TYPICAL CROSS SECTIONS - FOR BEDS NO 2 & 3

HELVETIA COAL CO. ENGINEERING DEPT. INDIANA, PA.	
DRAWING NO 3 (PHASE II) PROPOSAL	
LUC NO. 6 FILE	
MADE BY: REF	SCALE: AS SHOWN
TRACED BY:	DATE:
CHECKED BY:	NO.

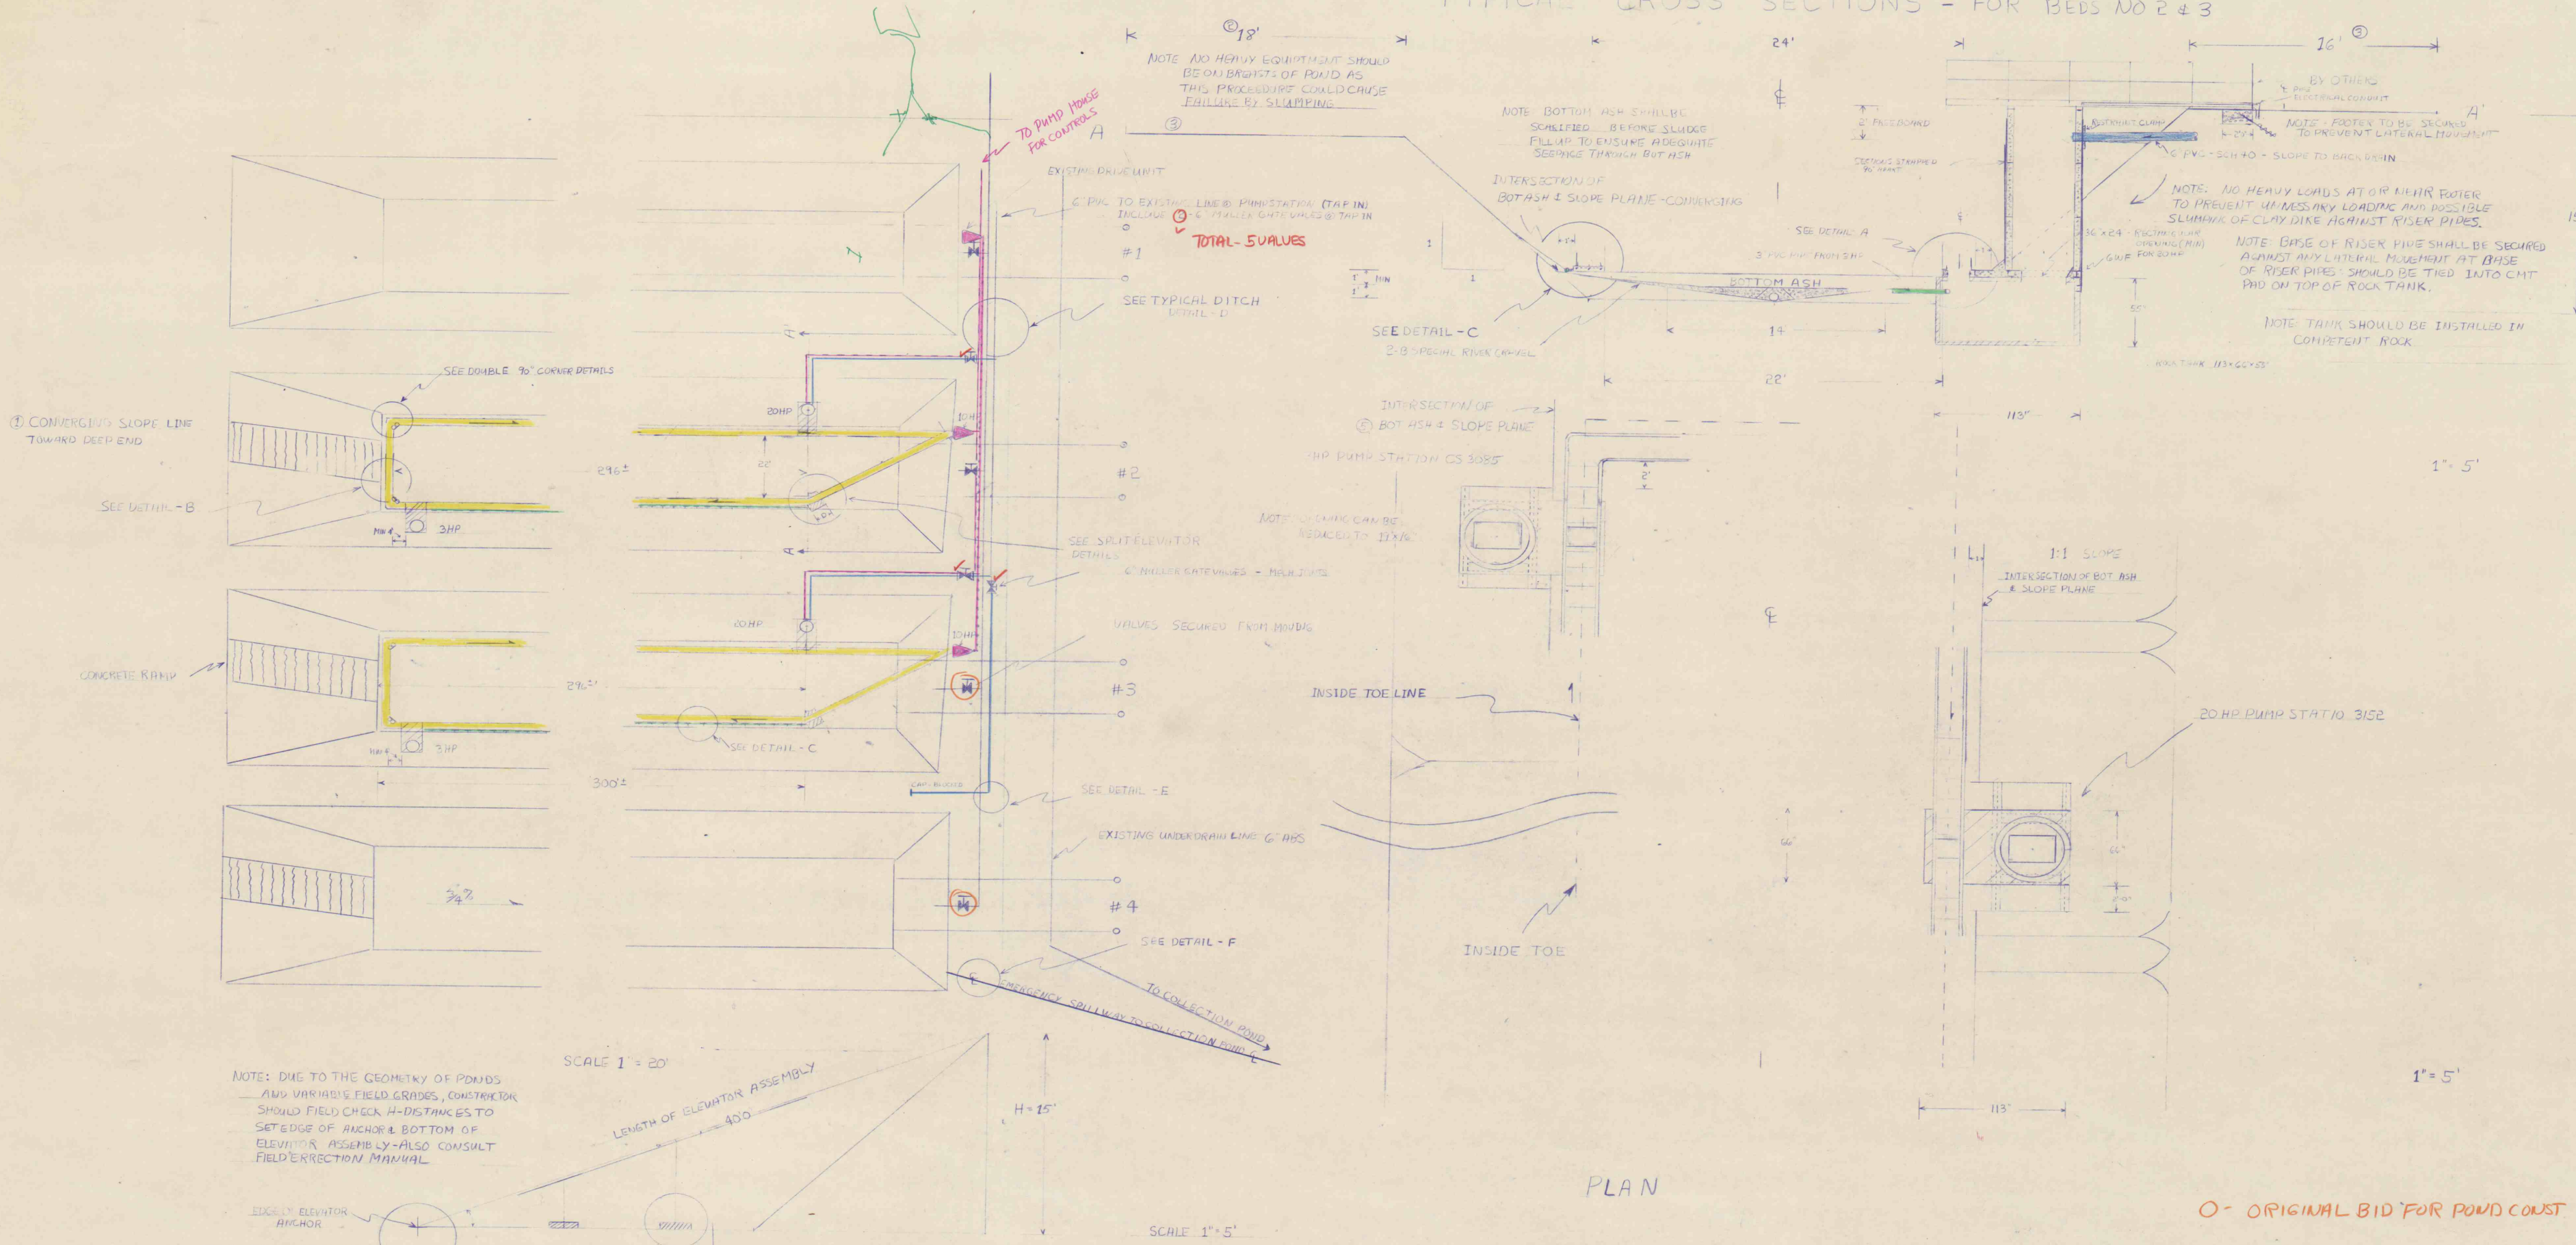
- NOTES
1. BOTTOMS OF PONDS NARROW DUE TO CONVERGING SLOPES
 2. THIS WIDTH ISN'T NECESSARY IF THERE ISN'T GOING TO BE ANY TRAFFIC ON BREAST
 3. TRAFFIC ON THESE BREAST WILL CONTRIBUTE TO DETERIORATION OF THE DIKES ESPECIALLY WHEN DIKES ARE SATURATED WITH WATER AFTER FROST LEAVES GROUND.
 4. PLAN OF CMT TROUGH REPRESENTS MOST ECONOMIC WAY TO CONSTRUCT ASSEMBLY
 5. INTERSECTION OF BOT ASH & SLOPE PLANE
